Stormwater Division

General File ID or BMP ID: PC193

County Plan No.: SP-118-03 AMINOS SP-25-03
 Project Name: NEW TOWN SEC 2 BLVD 2 PARCELA
 Stormwater Management Facility: BIORETENTION BASIN # 2-1
 BMP Phase #: I II III

ENVIRONMENTAL DIVISION REVIEW COMMENTS
NEW TOWN, SECTION 2, BLOCK 2
COUNTY PLAN NO. SP - 25 - 03
May 28, 2003

RECORD DRAWING
NEWTOWN BLOCK 2
BIORETENTION CELL #2-1
ID CODE #PC-193

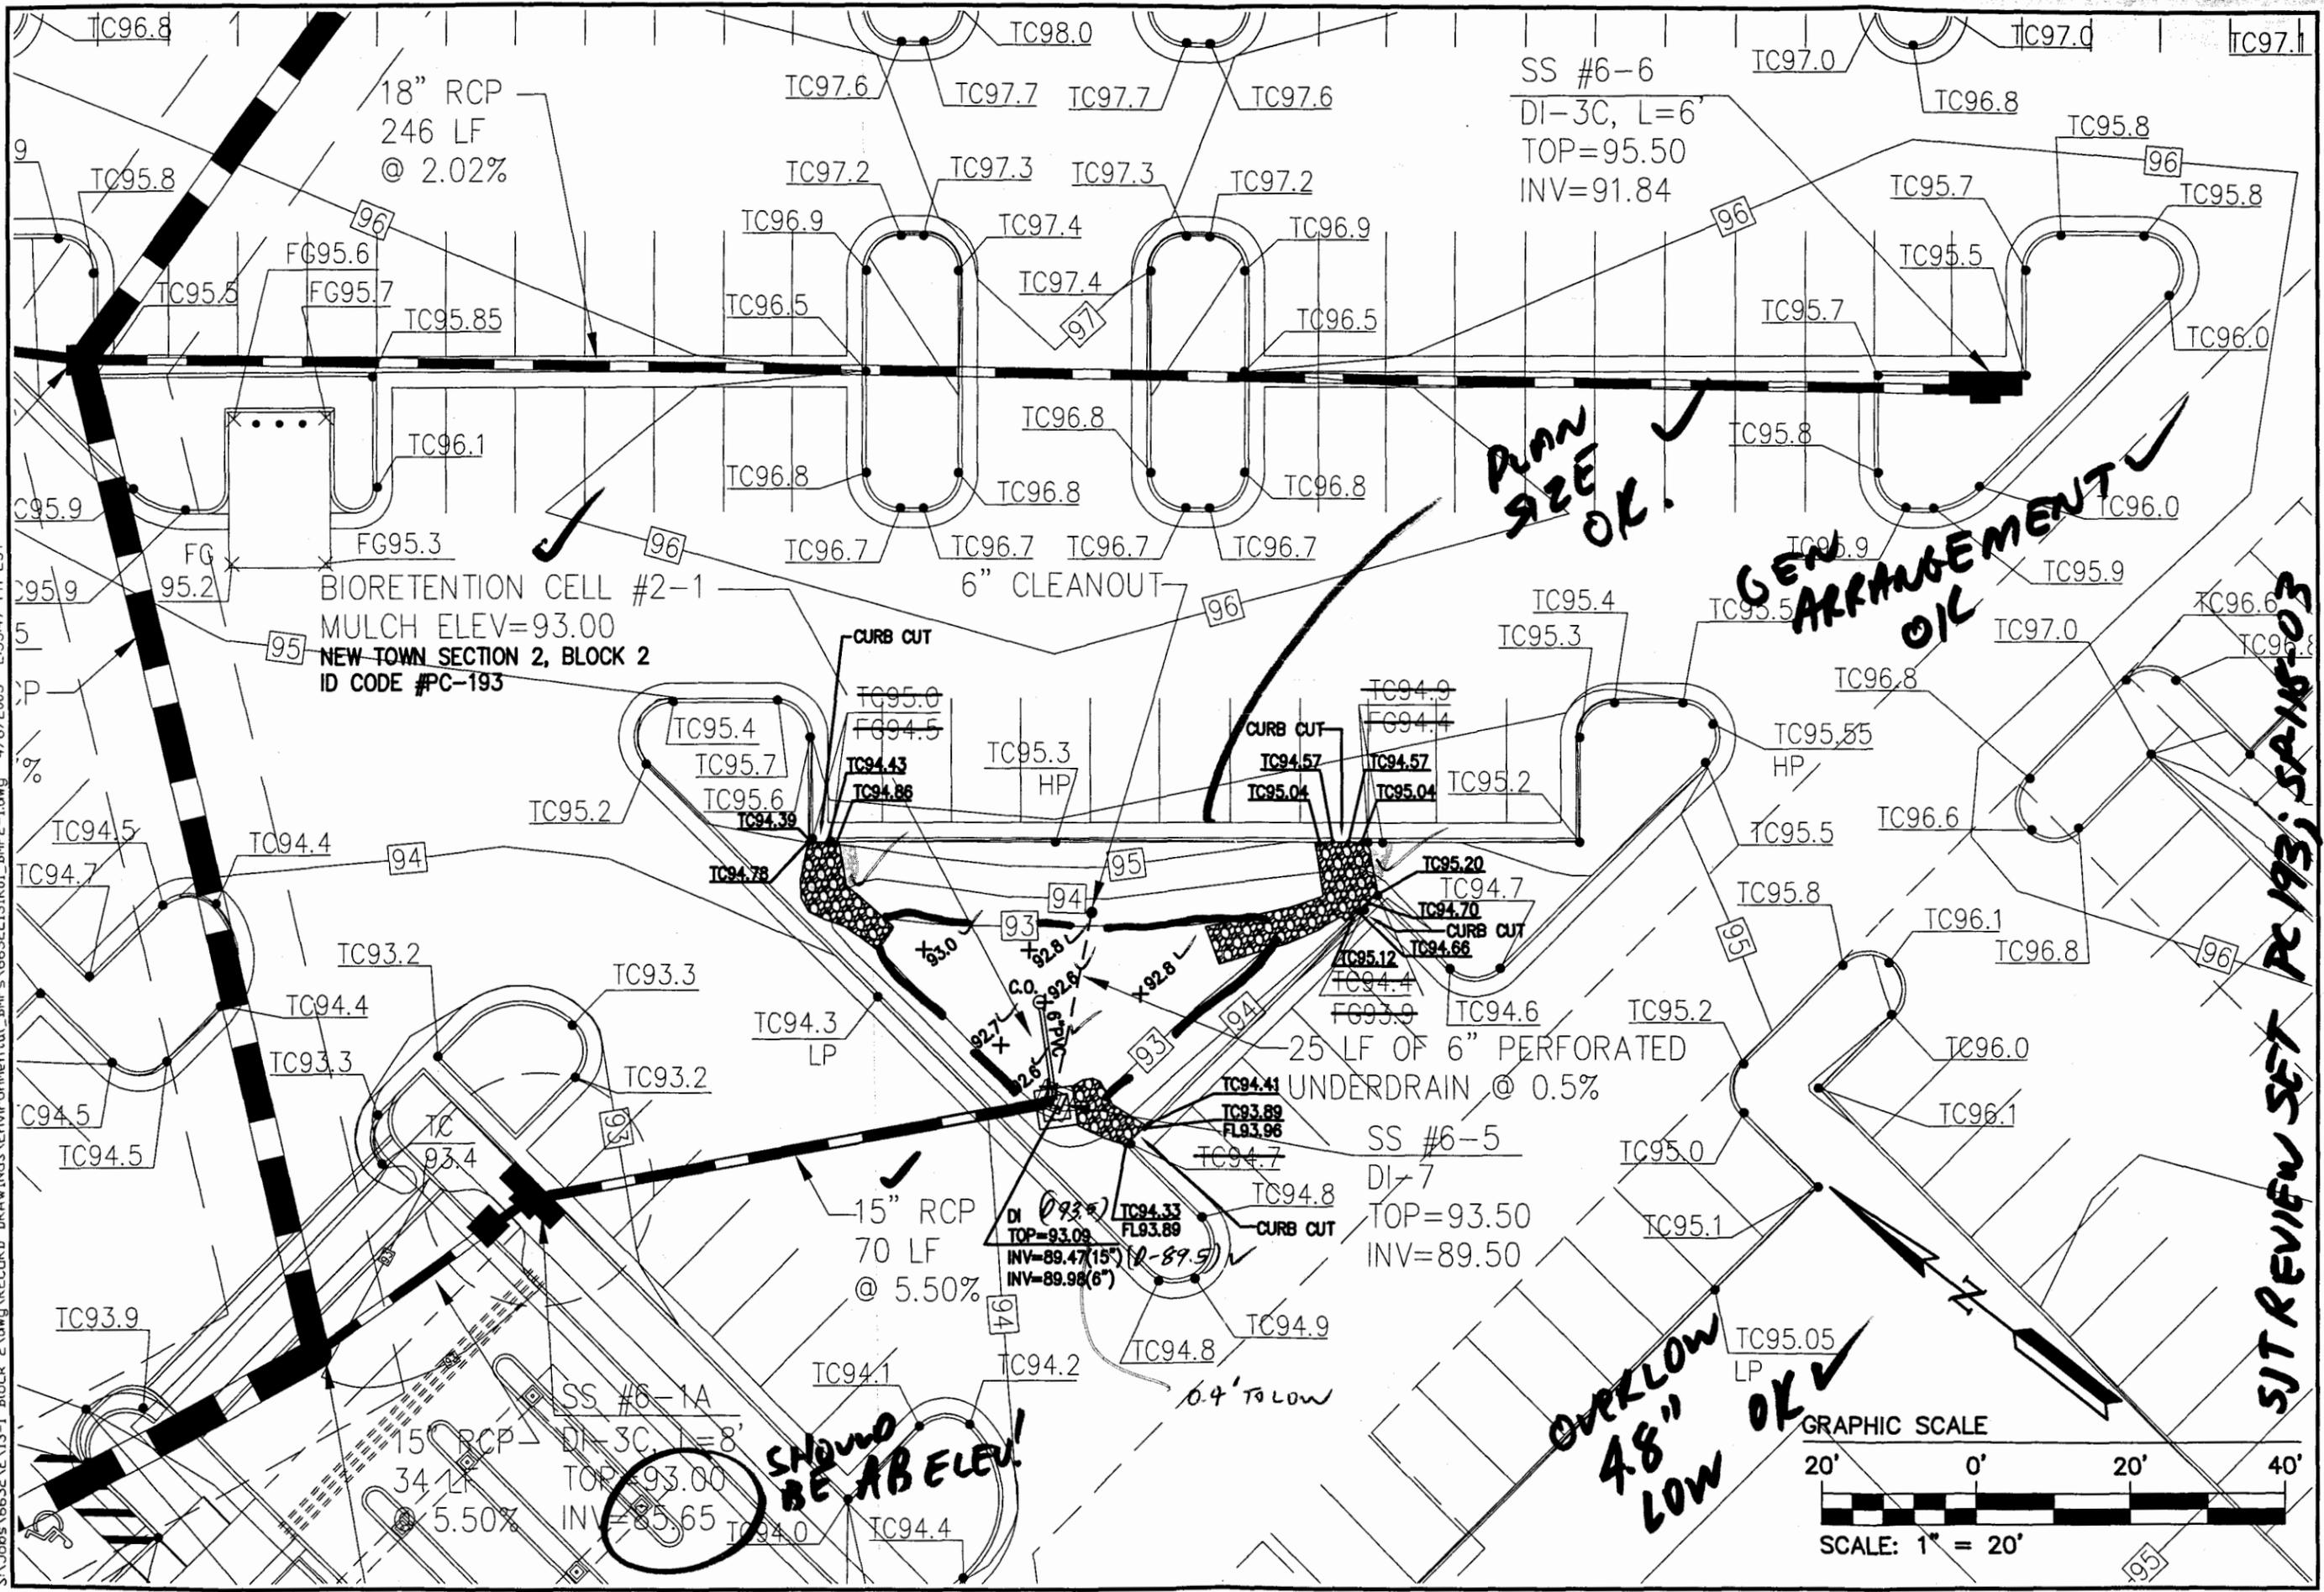
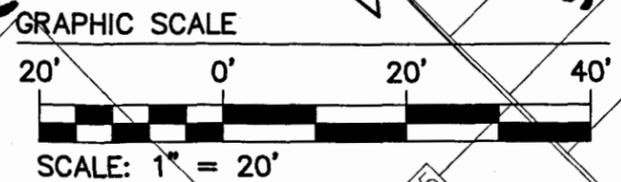
PLAN SIZE OK ✓

GEN ARRANGEMENT OIL ✓

SHOULD BE AB ELEV!

Hydraflow Plan View

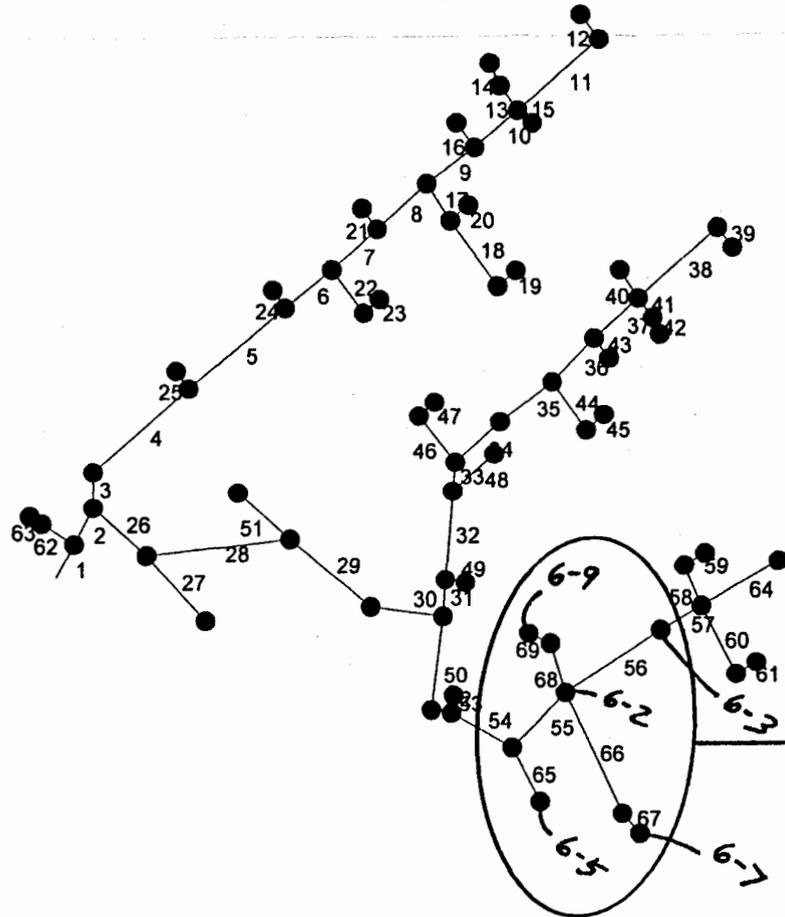
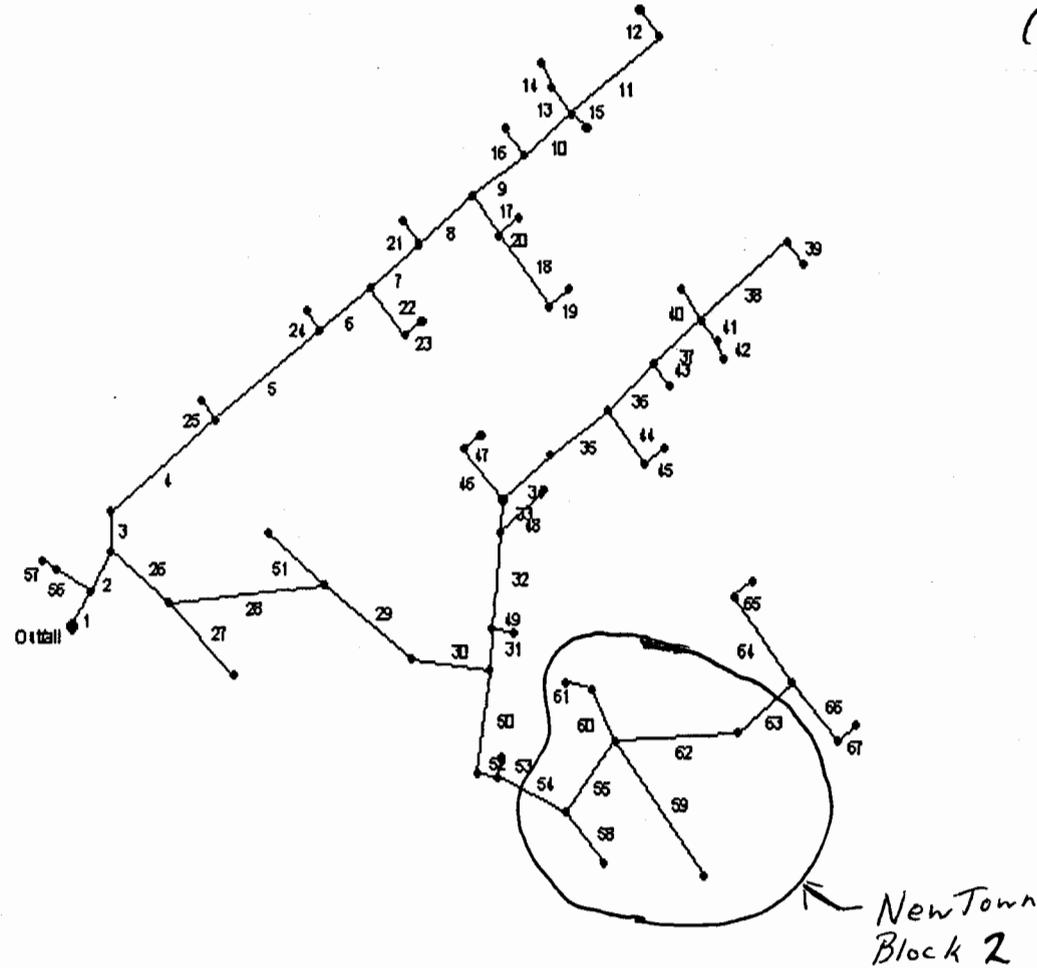
Need see Comps.

Hydraflow Plan View

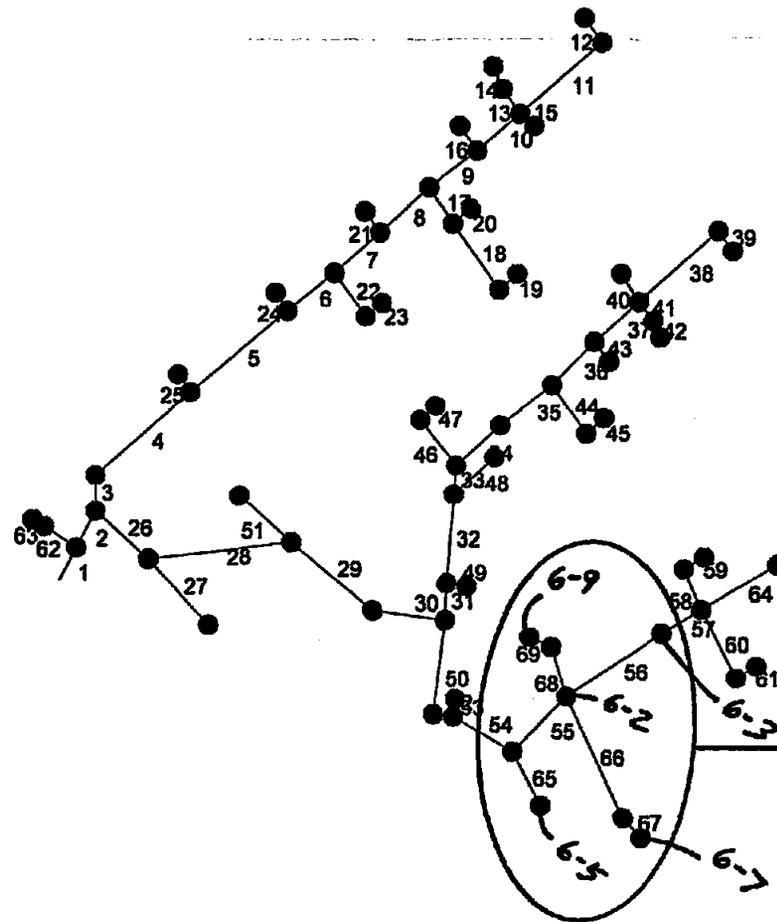
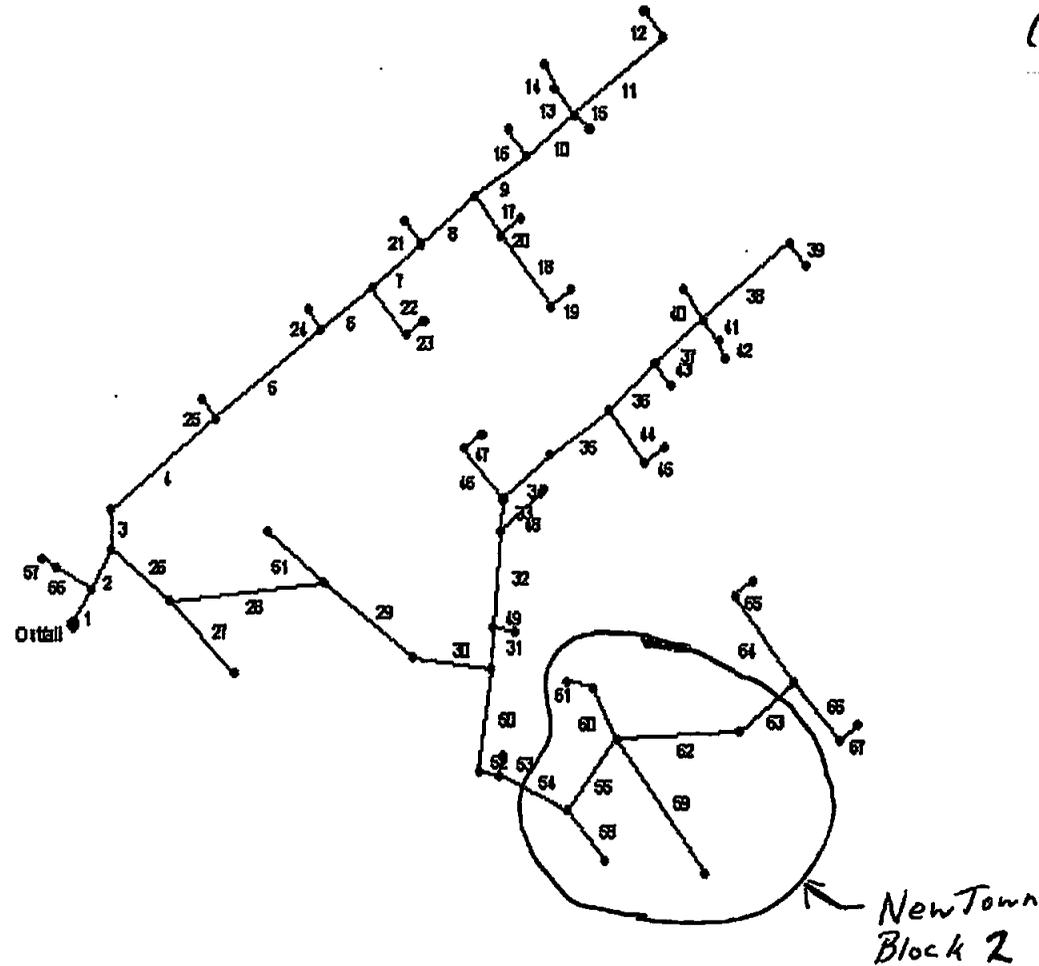
*Need see Comps.
5-25-03*
